Access Compliance Report

Public Rights-of-Way

(Curb Ramps)

Intersection ID: 3026	Main Street: FOX_HILL_DR	Cross Street: FOX_TROT_DR	Location:	W
ADA ID: FCFADF57B8A7	Ramp Type: Perp	Initial Pass/Fail: Fail	Overall Compliance: No	Severity Score: 8.75
Codes/Mitigation Info/Possible Solution		Field Measurements/Component Compliance

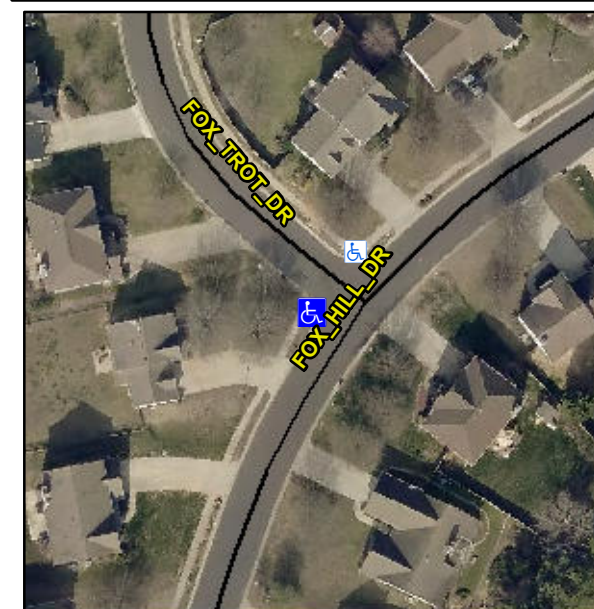
Not Found, R304.5.1

Compliance	Description	Data	Compliance	Description	Data
N/A	Ramp Length (in)	38.0	Yes	Ramp Slope (%)	6.5
No	Ramp Width (in)	47.5	Yes	Ramp XSlope (%)	0.1
N/A	Flare Type LT	N/A	N/A	Flare Type RT	N/A
N/A	Flare Slope LT (%)	N/A	N/A	Flare Slope RT (%)	N/A
N/A	Flare Traversable LT?	N/A	N/A	Flare Traversable RT?	N/A
N/A	Landing Length (in)	N/A	N/A	DWS Provided?	N/A
N/A	Landing Width (in)	N/A	N/A	DWS Contrast?	N/A
N/A	Landing Slope (%)	N/A	N/A	DWS Length (in)	N/A
N/A	Landing X Slope (%)	N/A	N/A	DWS Full Width?	N/A
N/A	Landing Curb? (Y/N)	N/A	N/A	DWS Offset (in)	N/A
N/A	Shared Landing?	N/A			
N/A	Gutter Ponding?	N/A	N/A	Gutter Slope (%)	N/A
N/A	Gutter Lip Ht (in)	N/A	N/A	Gutter X Slope (%)	N/A
N/A	Painted X Walk1?	No	N/A	Painted X Walk2?	N/A
	X Walk 1 Direction	To NE		X Walk 2 Direction	N/A
N/A	X Walk 1 Width (in)	N/A	N/A	X Walk 2 Width (in)	N/A
	X Walk 1 Slope (%)	1.0		X Walk 2 Slope (%)	N/A
	X Walk 1 X Slope (%)	0.1		X Walk 2 X Slope (%)	N/A

Remove & Replace Entire Ramp.
